Technical Announcement

INDUSTRY AUTOMATION BU, DELTA ELECTRONICS, INC

Product Category	DOP-HMI	Model(s)	DOP-B Series	Security Classification	<input checked="" type="checkbox"/> General <input type="checkbox"/> Confidential <input type="checkbox"/> Top-secret
				ECN No.	N/A
Issued by	HMI PSM/FAE Division	Author(s)	Daisy Huang	Issue No.	HMI15061000
				Released Date	2015/06/10
Recipient	HMI Product Manager, BU Sales Representative, DGC, DEU, DPR, DES, DEK, DEJ, DIN

Delta is pleased to announce the immediate release of new DOPSoft version 2.00.04.09 patch for DOP series HMI. This release is an improvement, which includes new HMI model and bug fixes.

1. Fixed when upload/download HMI through CDC mode will cause error message “ No Response From HMI! ”.

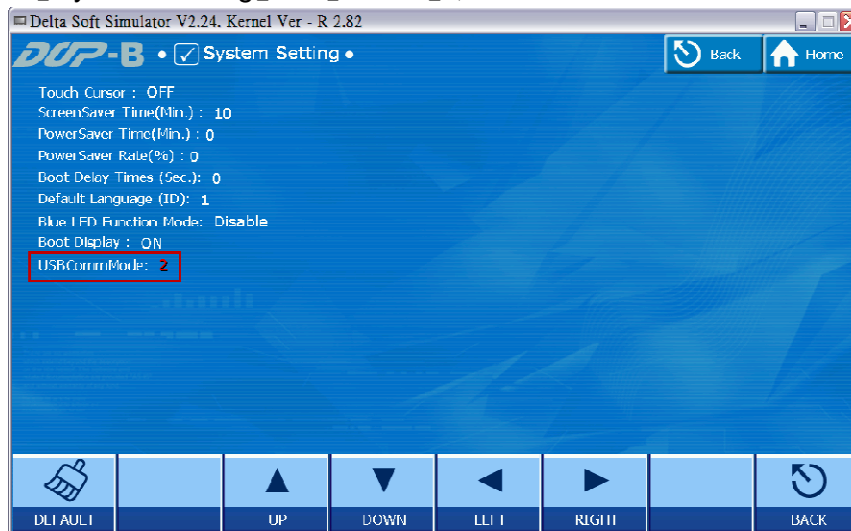
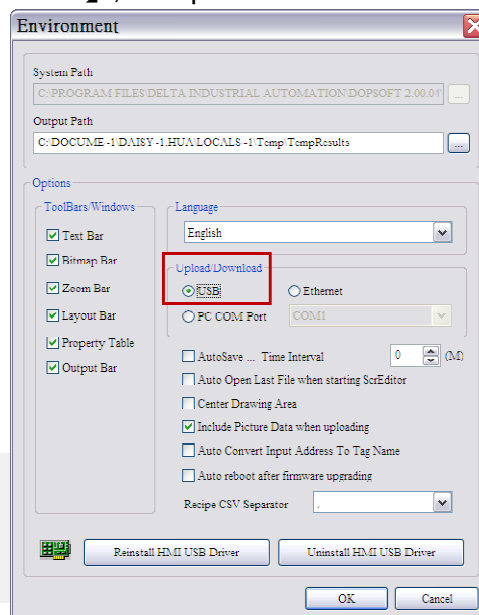
Step 1. Into **【Options】** → **【Configuration】** → **【Others】** , set USB Download to CDC.

Or Into System Menu **【System Setting】** → **【MISC.】** ,set USBCommMode to 2.

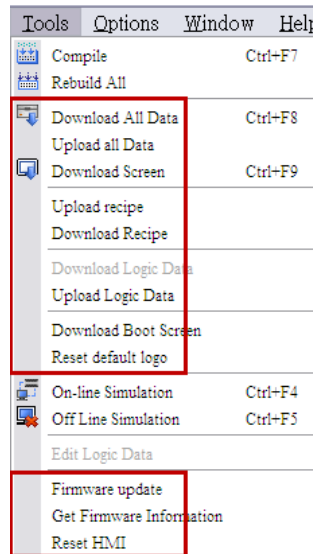
Step 2. Into **【Options】** → **【Environment】** ,set Upload/Download to USB.

Step 3. Execute Download/Upload function from DopSoft: 【Download All Data】 , 【Upload all Data】 , 【Download Screen】 , 【Upload Recipe】 , 【Download Recipe】 , 【Download Logic Data】 , 【Upload Logic Data】 , 【Download Boot Screen】 , 【Reset default logo】 , 【Firmware update】 , 【Get Firmware Information】 , 【Reset HMI】 .

Before :

DopSoft will pop up error message “ No Response From HMI! ”.

After :

DopSoft will execute Download/Upload.
